GM SERVICE AND PARTS OPERATIONS  
DCS1328  
URGENT - DISTRIBUTE IMMEDIATELY

Date: January 24, 2005  
Subject: 05010A - Product Safety Recall  
Intermediate Steering Shaft to Steering Gear Bolt  
Models: 2005 Chevrolet Silverado  
2005 GMC Sierra  
To: All Chevrolet and GMC Dealers  
Attention: Service Manager, Parts Manager and Warranty Administrator

# Recall Bulletin

**SUBJECT: INTERMEDIATE STEERING SHAFT TO STEERING GEAR BOLT**

333146

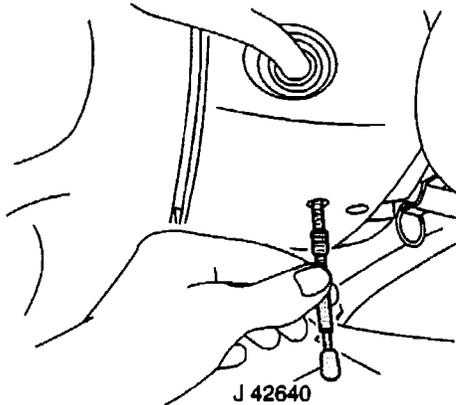
General Motors has decided that a defect, which relates to motor vehicle safety, exists in **certain** 2005 Chevrolet Silverado and GMC Sierra vehicles. The bolt that attaches the intermediate steering shaft to the steering gear may not meet specification. The bolt may fracture, resulting in the loss of steering. If this happens while the vehicle is moving, a crash could occur without prior warning.

Dealers are to replace the intermediate steering shaft to steering gear bolt. Dealers are to contact customers of delivered vehicles to make arrangements to have their vehicle towed to the dealership for repair.

2. Install J 42640 in the steering column lower access hole.
3. For vehicles equipped with a 6.6L diesel engine, remove the left charge air cooler hose.
4. Remove the bolt from the lower shaft coupler.
5. Install the new bolt to the lower shaft coupler. **Tighten**

Tighten the coupler pinch bolt to 47 N·m (35 lb ft).

6. For vehicles equipped with a 6.6L diesel engine, install the left charge air cooler hose.
7. Remove J42640 from the steering column lower access hole.
